## ADDENDUM NO. 1

December 8, 2025

TANG HALL LABORATORY  
FIT-OUT

PROJECT NO: 250800	DATE: 11/07/2025
PHASE: BID SET	SCALE: 1/4" = 1'-0"

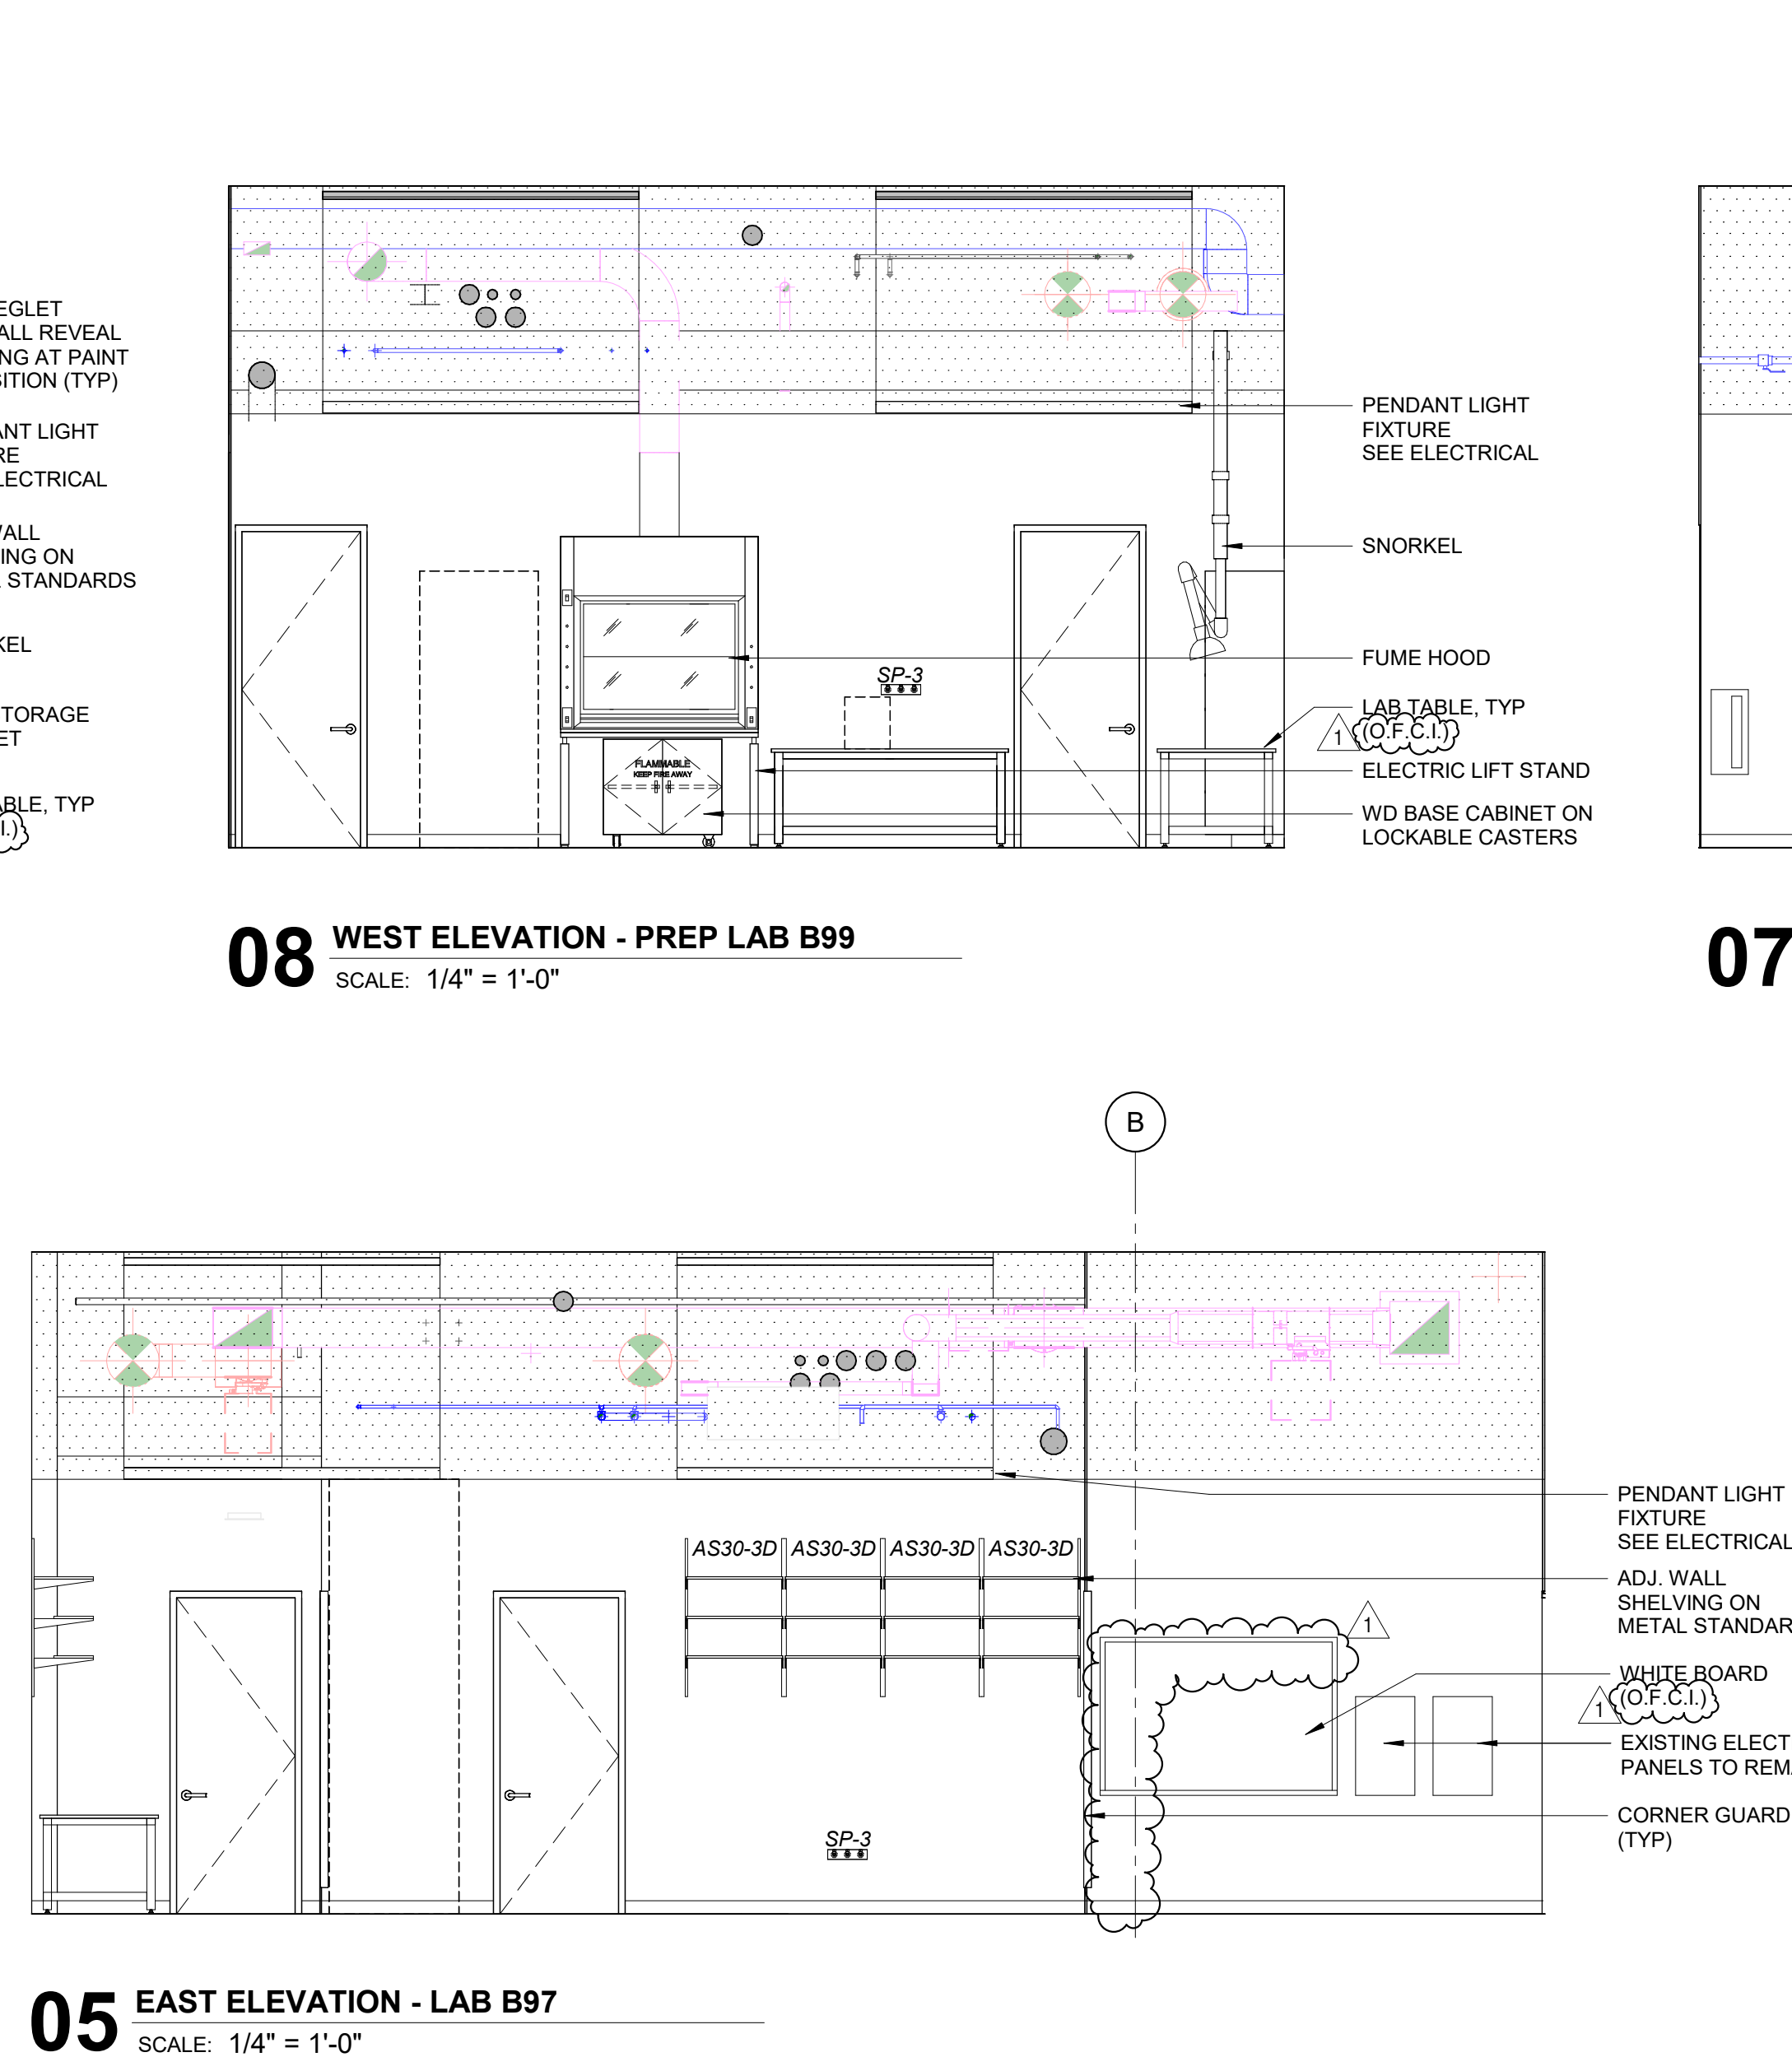
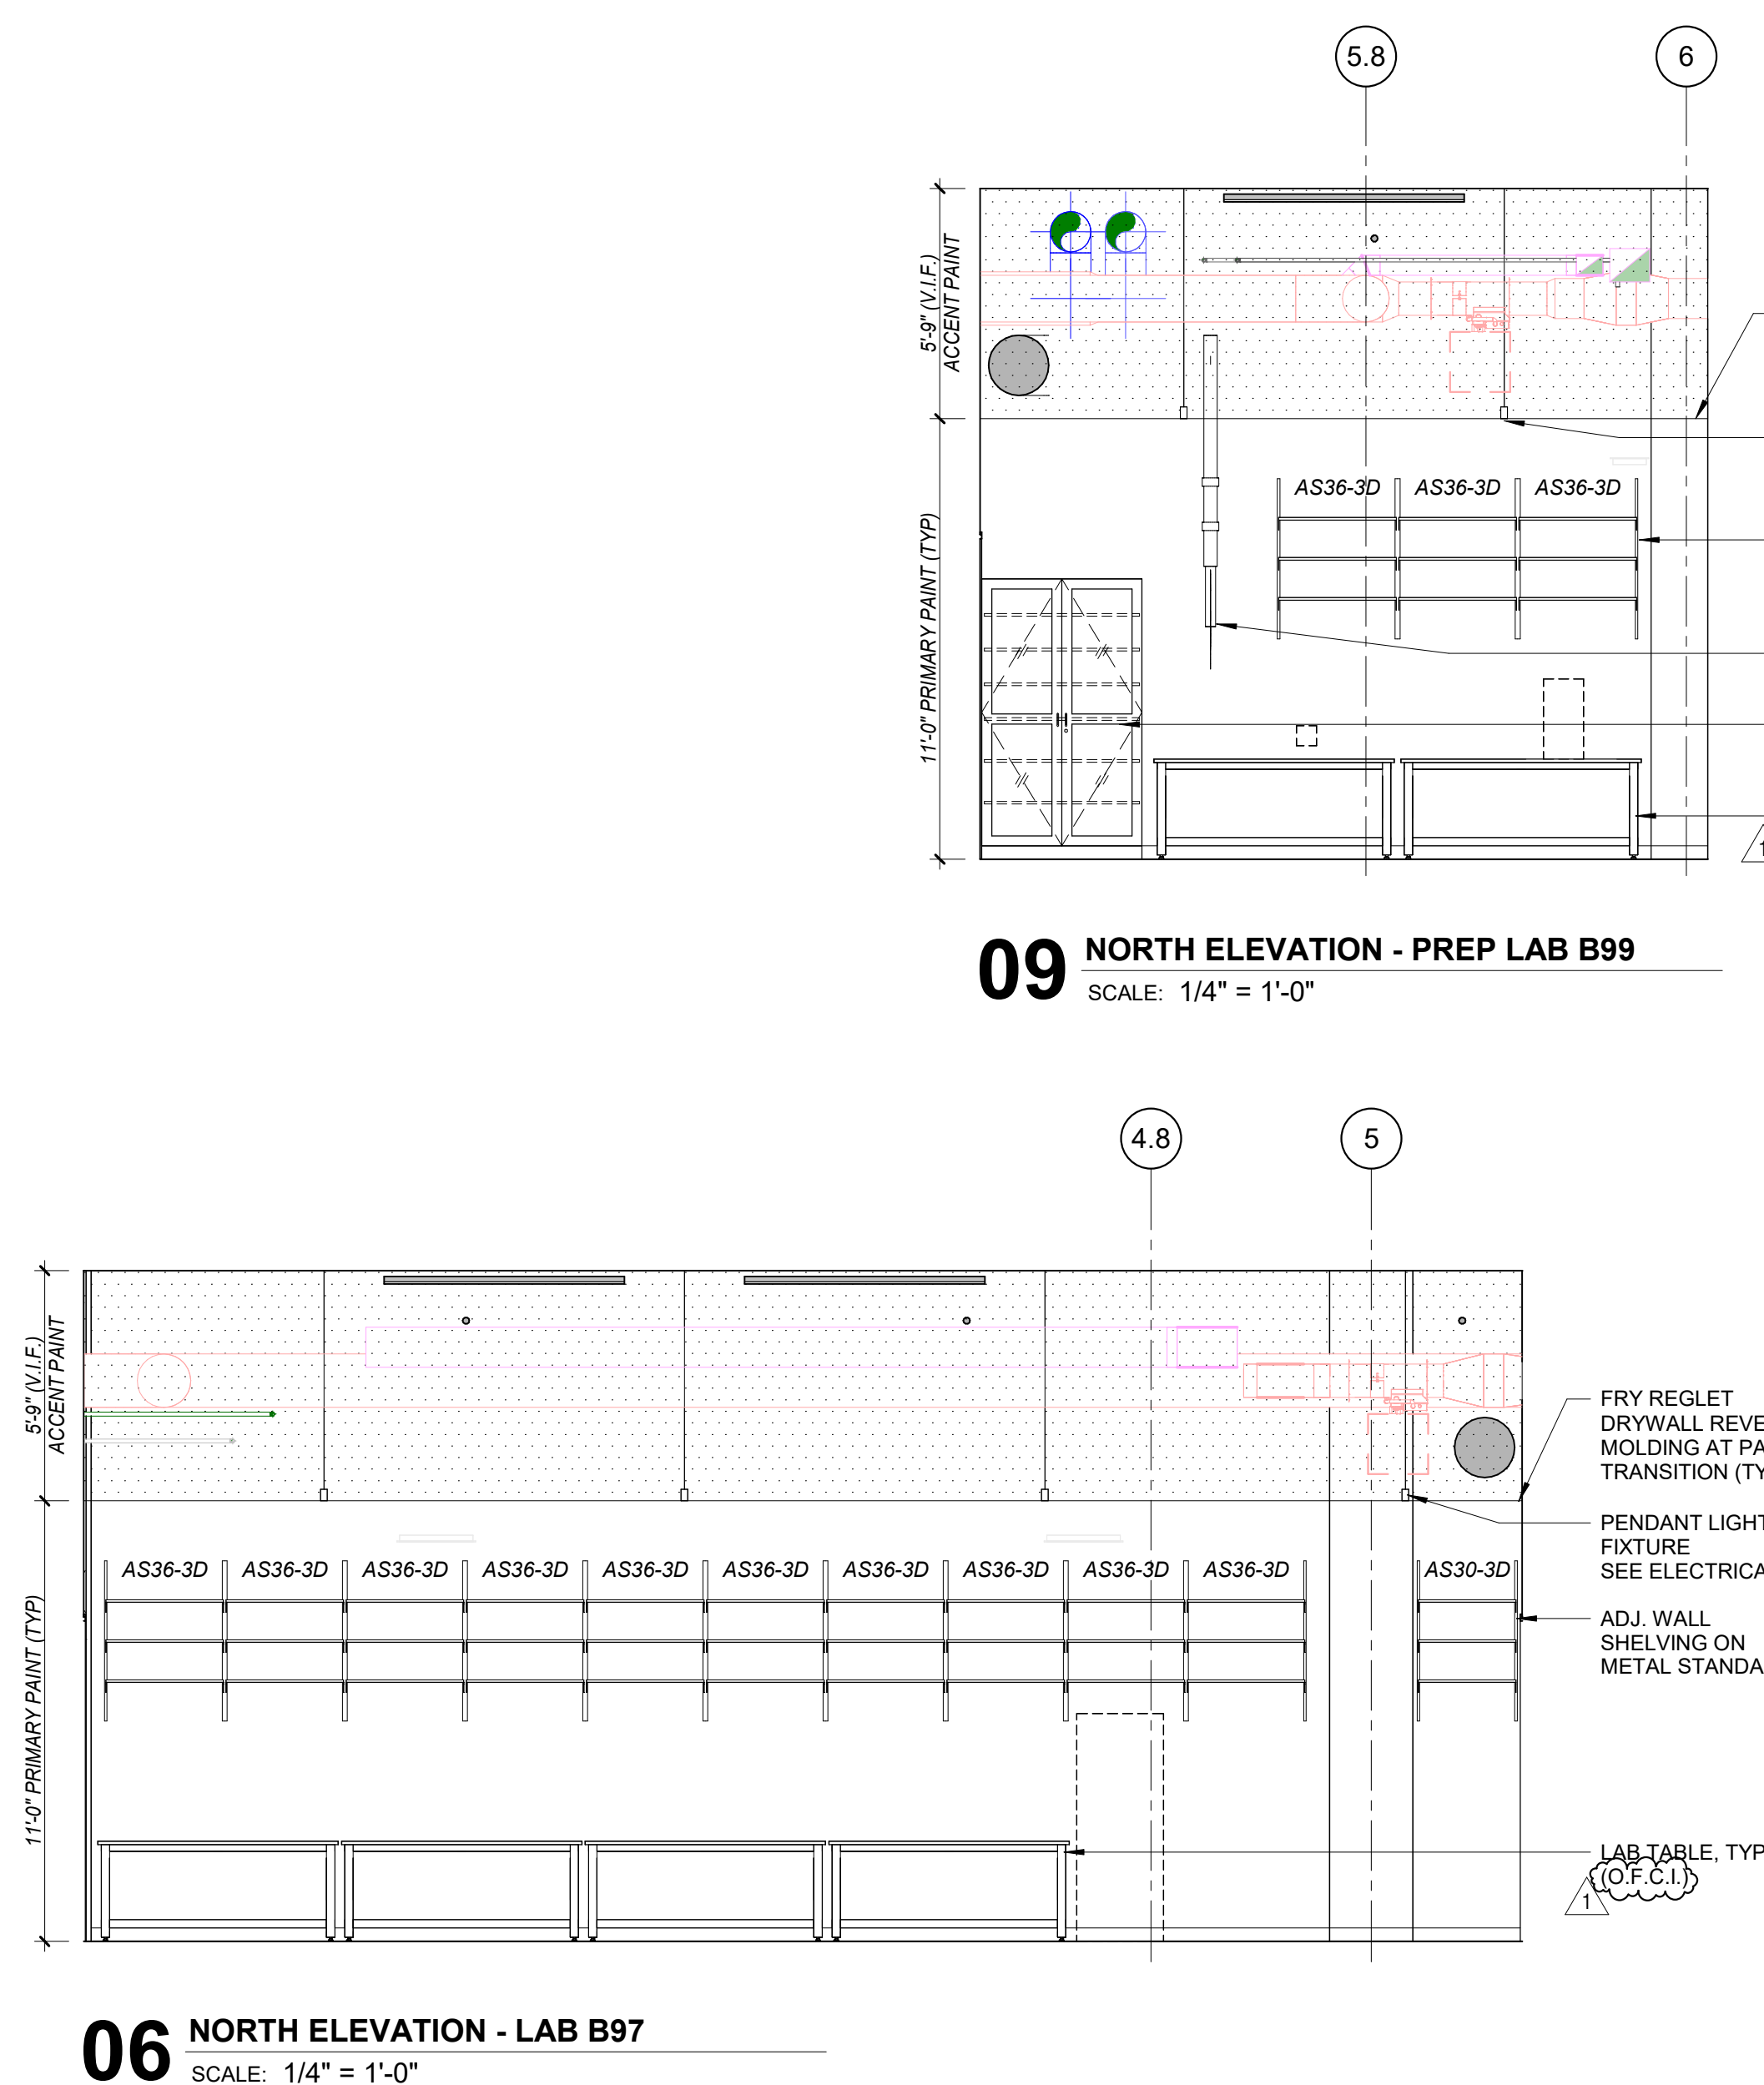
**DELETE** premix gas turret at wall. See Item 13 for reference.

Item 16. Drawing A-910R, all lab tables shown at Lab B97, B99 & B99B to match plan drawing

**REPLACE** notes in elevations to indicate all lab tables to be “**O.F.C.I.**” (Owner furnished, Contractor installed), to match plan drawing A-900.

Item 17. Drawing A-910R, whiteboards

**REPLACE** note in elevations to clarify whiteboards to be “**O.F.C.I.**” (Owner furnished, Contractor installed). See Item 12 for description.
